## ANN ARBOR HISTORIC DISTRICT COMMISSION

### Staff Report

**ADDRESS:** 121 Crest Avenue, Application Number HDC22-1198

**REPORT DATE:** October 13, 2022

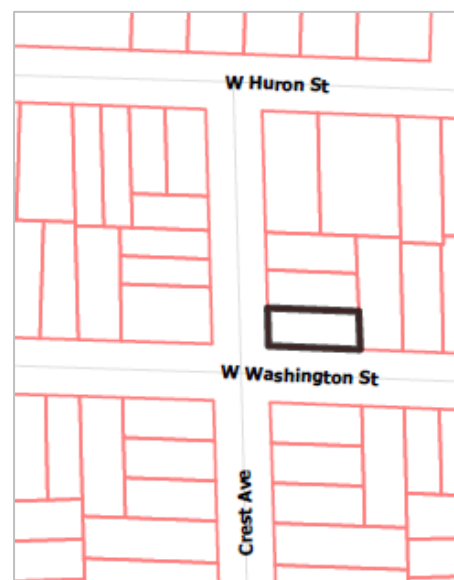
**BACKGROUND:** This 1 ¾ story gable-fronter features 3/1 and 4/1 windows, exposed rafter tails, a round attic window in the front gable, a full-width shed-roof front porch with tapered square half-columns on a solid wall clad with siding to match the house.
